**DUNE ND-SAND PDR: KLOE Components to SAND**  
(<https://indico.fnal.gov/event/64578/> )  
**Questions and Answers**

This document aims to capture questions and answers during the preliminary design review of the DUNE ND KLOE Components to SAND held on July 22-23, 2024

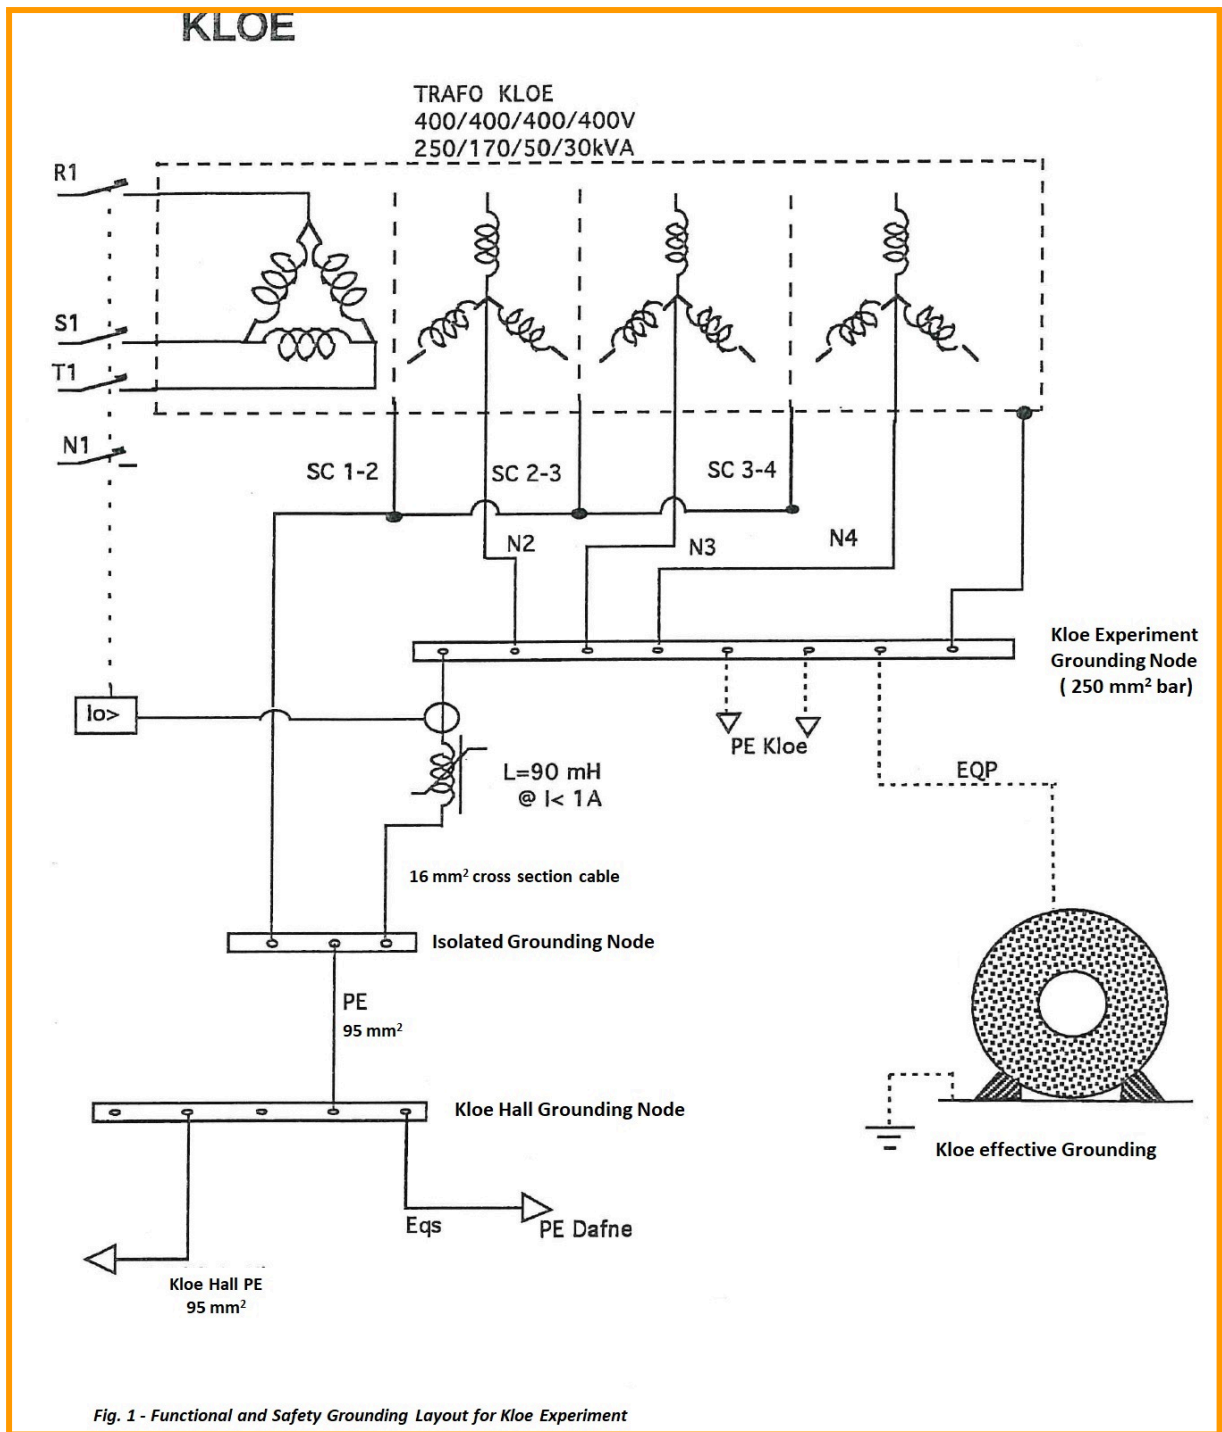
25. The support of the mechanical structure inside a superconducting magnet is normally minimal to minimize the resulting heat leak. Often manufacturers will provide temporary supports for use in transportation. Were such temporary bracing members needed in the initial transport? Have there been calculations showing that no additional bracing is needed for the ocean transport?

The vessel structure of the KLOE magnet has been over-designed in consideration of the need to support the barrel ECAL (85 tons). Therefore no braces have been used by OXFORD for the transport from England to Frascati, through the Atlantic Ocean and the Mediterranean Sea. We will confirm the calculation once the details of the transport will be settled.
